**SITE PLAN REVIEW SHEET
ENVIRONMENTAL VARIANCE REQUEST ONLY**

CASE NO: SP-2022-0516C

SITE PLAN NAME: HCA Behavior Health Hospital

1. Vary from LDC 25-8-342 to allow fill to 14 feet.

HCA BEHAVIORAL HEALTH
2411 PARK BEND DRIVE
CITY OF AUSTIN, TRAVIS COUNTY, TEXAS
SITE CUT-FILL EXHIBIT

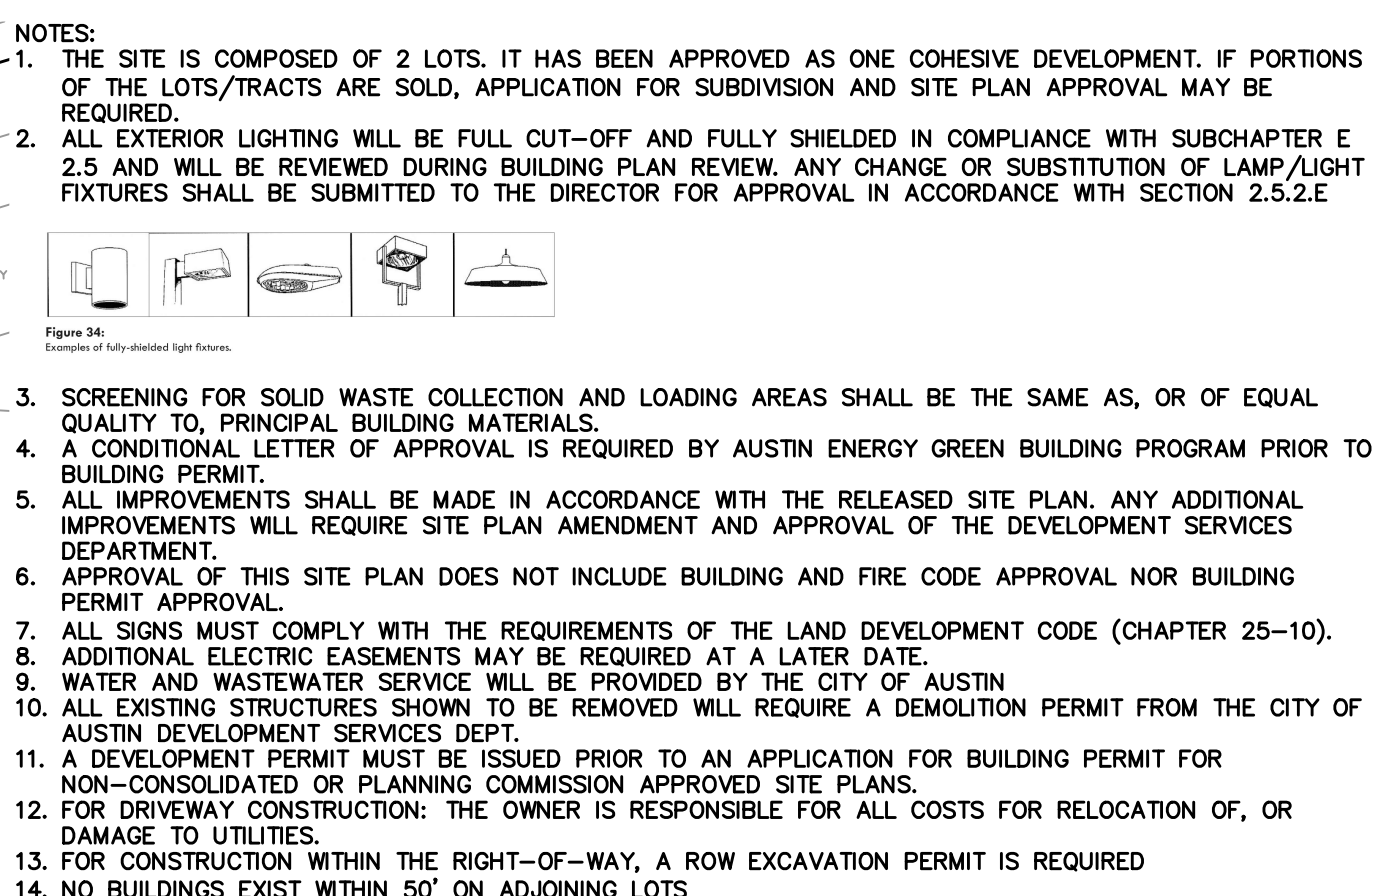
Clearly indicate in what way the proposed project does not comply with current Code (include maps and exhibits)	The proposed site development includes fill greater than 4' (max fill is 13.1')
---	---

1. Contain the fill with a combination of engineered walls and terraces to reduce grading and increase infiltration.
2. Seed and plant the terraces with native trees (where feasible based on structural constraints), perennials, grasses, and forbs per 609S to increase infiltration, provide habitat, and increase plant diversity. Providing NO MOW signage for the terraces.
